Research Reactor Center

Reference: Docket 50-186
University of Missouri – Columbia Research Reactor
Amended Facility License R-103

SUBJECT: Written communication as specified by 10 CFR 50.4(b)(1) requesting U.S. Nuclear Regulatory Commission approval to amend the Technical Specifications appended to Facility License R-103 pursuant to 10 CFR 50.59(c) and 10 CFR 50.90

TECHNICAL SPECIFICATION
UNIVERSITY OF MISSOURI
RESEARCH REACTOR FACILITY

Figure 6.0

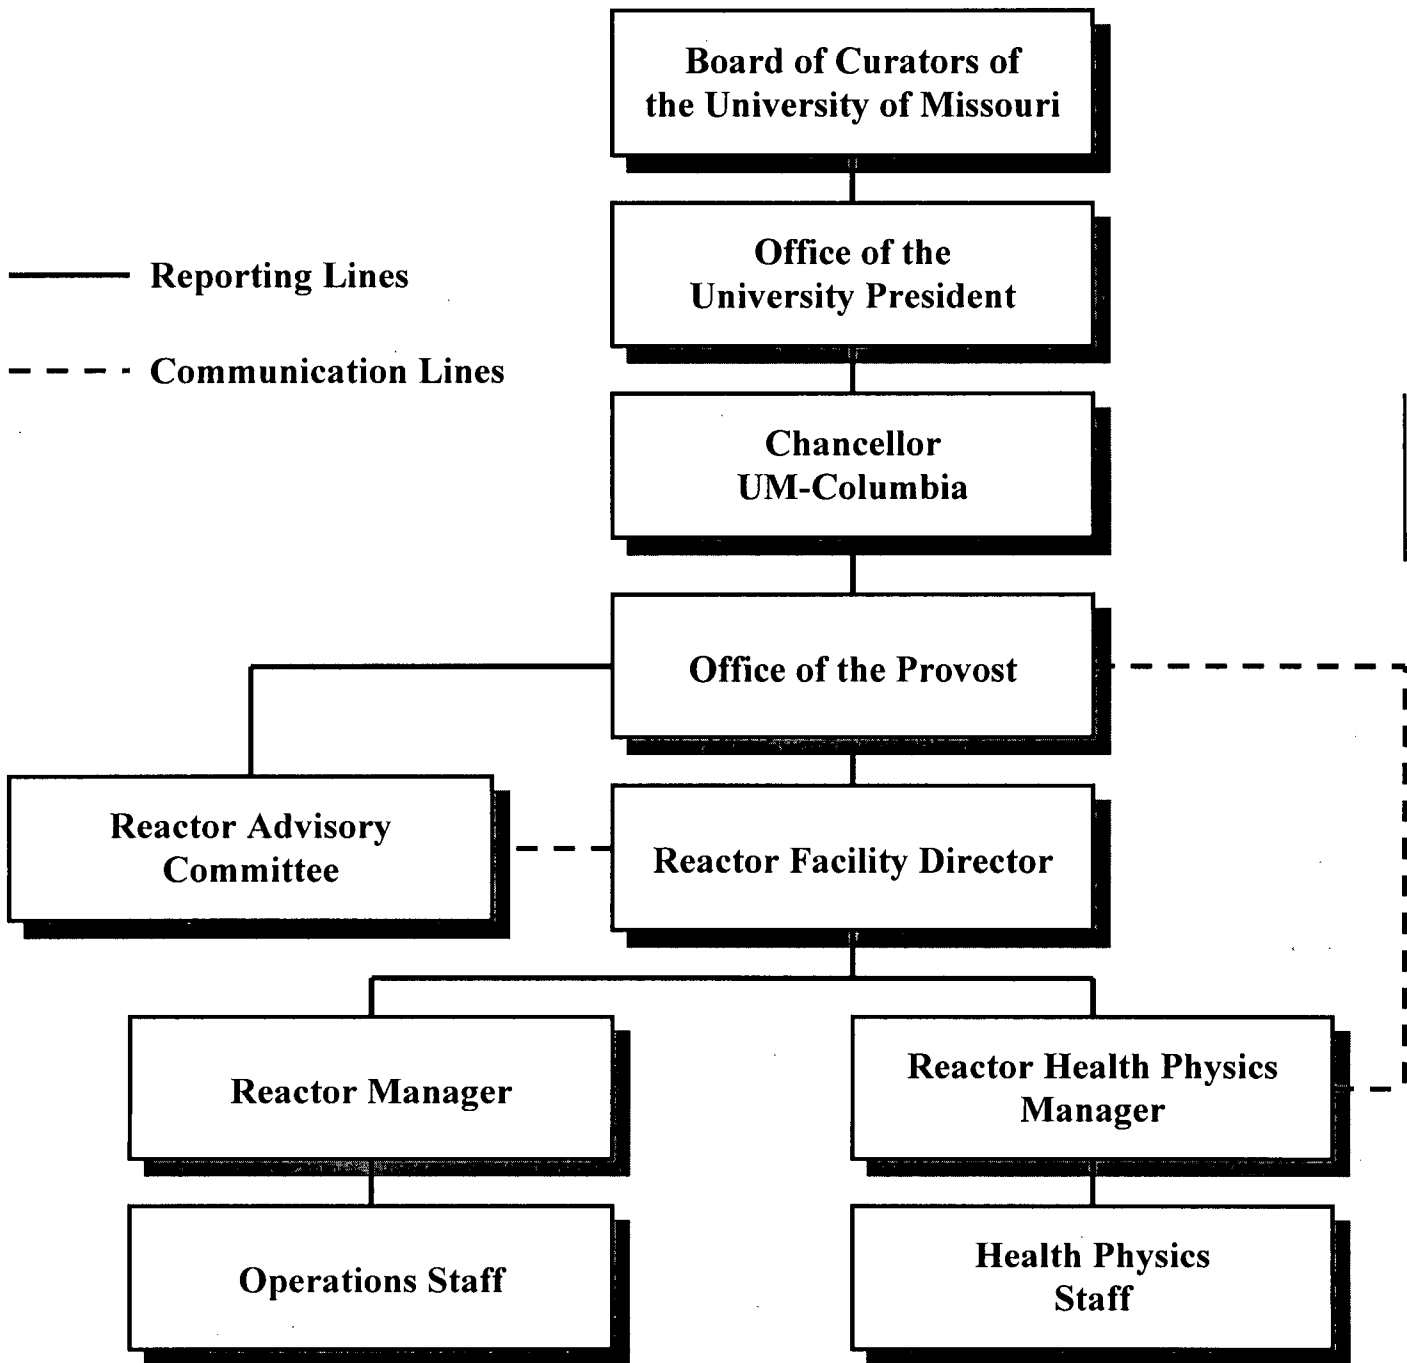
The University of Missouri Research Reactor (MURR) is requesting a change to the facility Technical Specifications (TSs) that modifies the organization for the management and operation of the reactor by re-inserting the Office of the Chancellor in Section 6.0 of the MURR TSs as the primary University official responsible for its activities.

Attached is the TS page that will implement the requested change. If there are questions regarding this request, please contact me at (573) 882-5276. I declare under penalty of perjury that the foregoing is true and correct.
